Contract #: 04-0120F4Cty: SF/ALA Rte: 80 PM: 13.2/13.9File #: 69.25B**QUALITY ASSURANCE -- NON-CONFORMANCE REPORT****Location:** Changxing Island, Shanghai, P.R. China**Report No:** NCR-000746**Prime Contractor:** American Bridge/Fluor Enterprises, a JV**Date:** 27-May-2010**Submitting Contractor:** Zhenhua Port Machinery Company, Ltd (ZPMC), Changxing Island**NCR #:** ZPMC-0709**Type of problem:**

Reference Description: Missed UT indication by QC on OBG Segment 10CE Upper Floorbeam Flange (PP94)

Subject: NCR No. ZPMC-0709

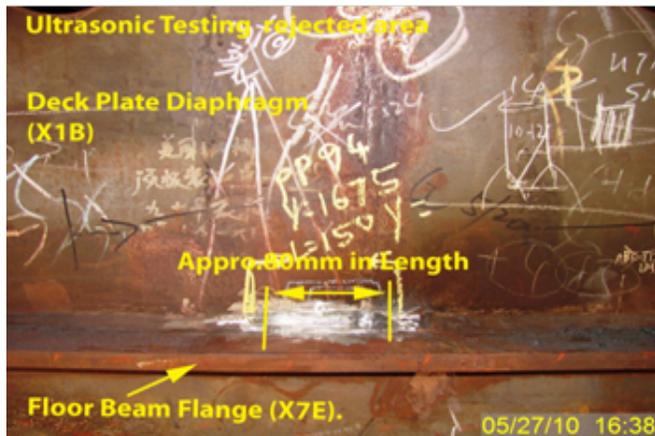
- One (1) longitudinal linear indication measuring approximately 80mm in length.
 - The indication dB rating is a +4.
 - Material thickness is 14mm.
 - The depth of the indication is approximately 10mm.

- The weld is identified as SSD-PP94-001/002 at Crossbeam side, Panel Point (PP) 94.
 - According to the approved shop drawing and due to excessive root gap ZPMC has changed the joint to a Complete Joint Penetration (CJP) "T" joint.

- This joint joins the Deck Plate Diaphragm (X1B) to Floor Beam Flange (X7E).
 - The weld is designated as Non-Seismic Performance Critical Material (Non SPCM).

- The indication is clearly marked on or near the weld.
 - The Y distance for this indication is 1675 mm from the Corner Assembly diaphragm at the Crossbeam side.

- Segment 10CE is located outside of the Paint shop.
- The Notice of Witness Inspection (NWIT) No. is 005832. The indication is located in an area previously tested and accepted by ZPMC Quality Control (QC) personnel. As per the contract documents, ZPMC's QC personnel are required to perform hundred (100%) percent UT inspection of this weld.

Reference Resolution: ZPMC will provide NDT to show these welds are acceptable after the repairs are complete. Based on this proposal ZPMC requests that this NCR be approved, with actions pending.

This proposed resolution is accepted, action pending. Please provide NDT results for these welds upon completion of the repairs.

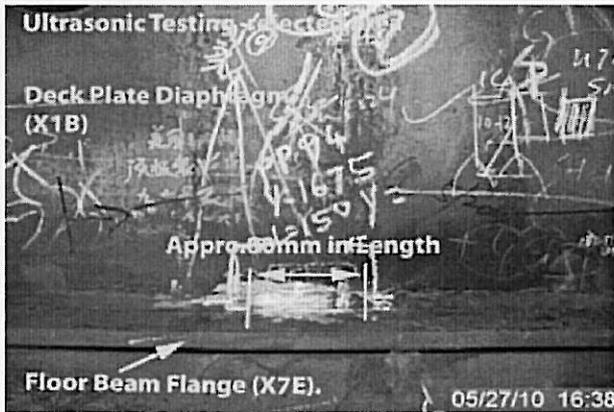
-One (1) longitudinal linear indication measuring approximately 80mm in length.

-The indication dB rating is a +4.

-Material thickness is 14mm.

-The depth of the indication is approximately 10mm.

-The weld is identified as SSD-PP94-001/002 at Crossbeam side, Panel Point (PP) 94.

-The indication is clearly marked on or near the weld.

-The Y distance for this indication is 1675 mm from the Corner Assembly diaphragm at the Crossbeam side.

WELD NUMBER: SSD18-PP94-303

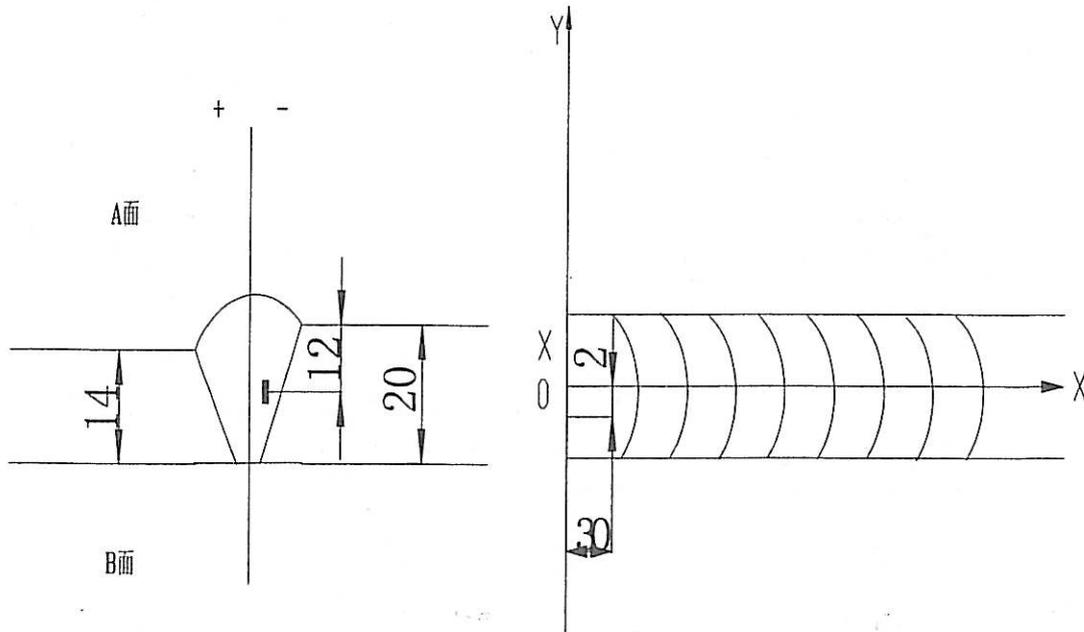
Rejected indication found by ultrasonic inspection is less than the maximum allowance aggregate length.

1. Did not clear the weld pass completely in time.

1. Gouge or grind from nearer side from metal edge ($D \leq 0.65T$, "D" is depth of defects, "T" is thickness of metal) to remove all defects;

2. Follow repair WPS for joint preparation, preheat, and weld deposit;

3. Verify with VT no defects remain in the weld joint prior to welding;

4. Grind the repaired area flush with base metal or the adjacent weld;

5. Check the welds according to the working drawings.

ZPMC
SHANGHAI ZHENHUA PORT MACHINERY CO., LTD.
WELDING MAP
DRAWN: [] CHECKED: [] SHEET NO: SSD 18 PAGES: 1/1

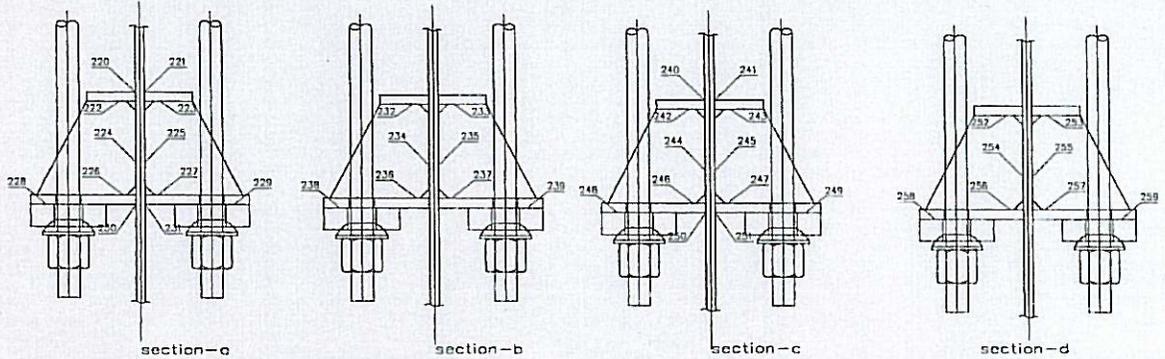
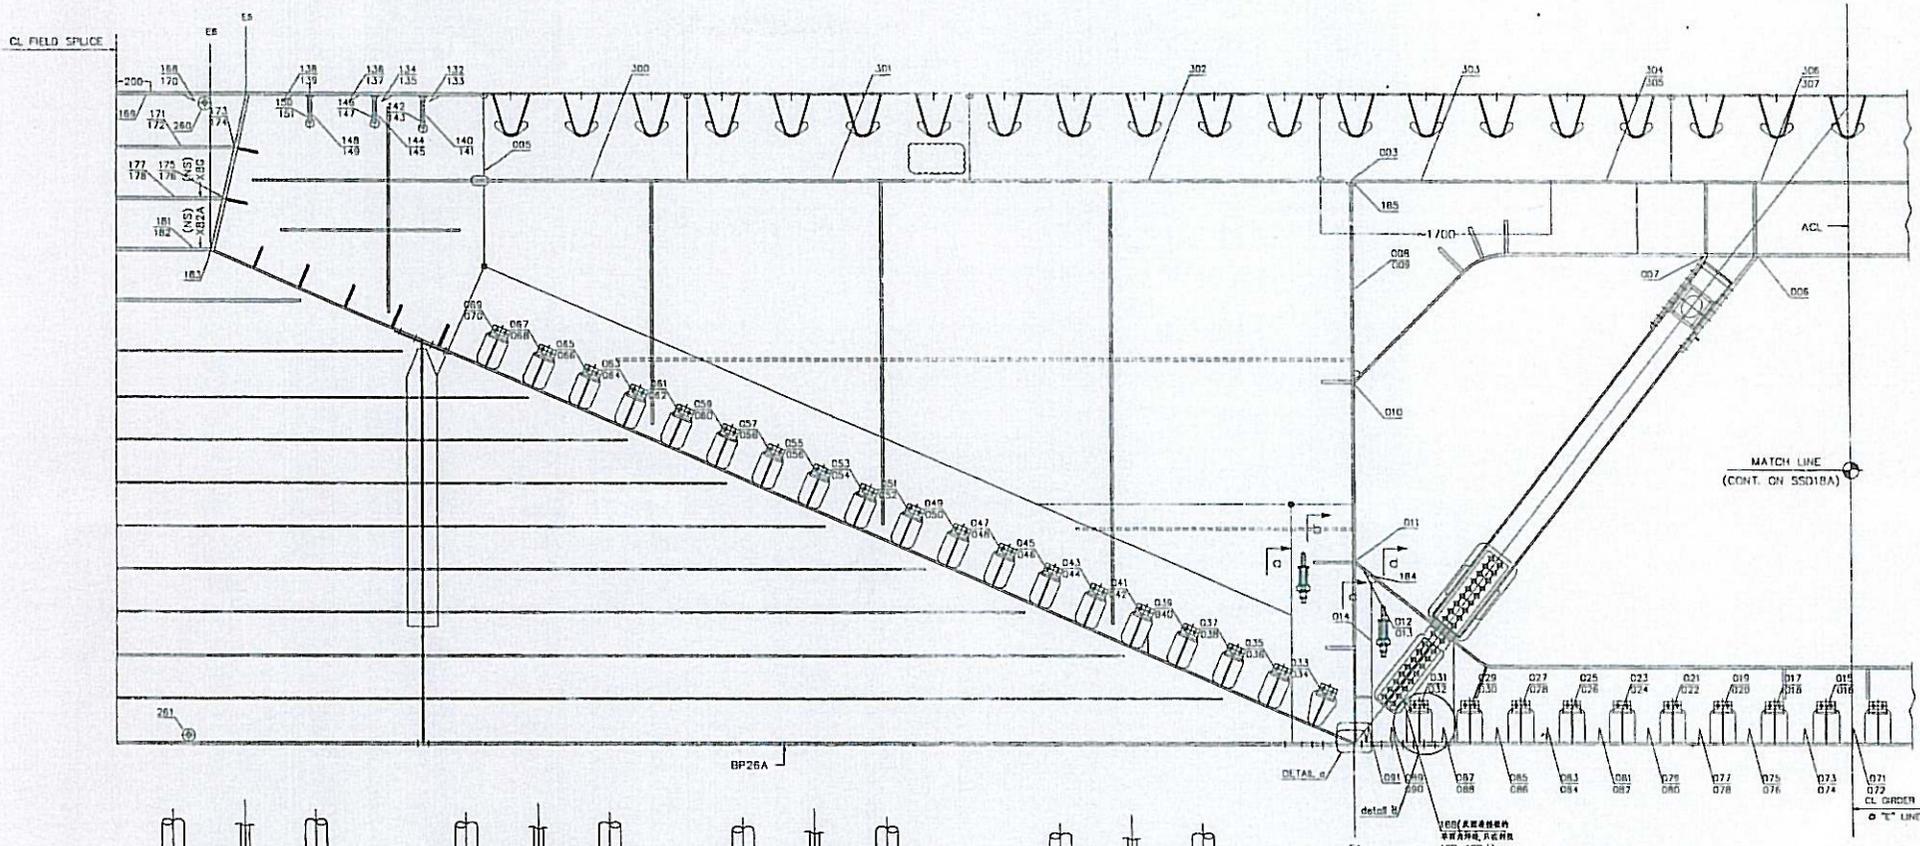
- 注意：
- 300~307焊缝编号仅用于PP94处。
 - 原角焊缝 140/141 在SSD18-PP094由CJP焊缝号140替代，但在SSD18其余PP点位置不作修改。
 - 焊缝272、273、274在PP58、64，其他位置不存在。
 - 原角焊缝144\145在SSD18-PP70由CJP焊缝号144替代其他位置不作修改

P.S: The fillet weld SSD-PP94-001/002 has been changed to CJP(SSD18-PP94-303)
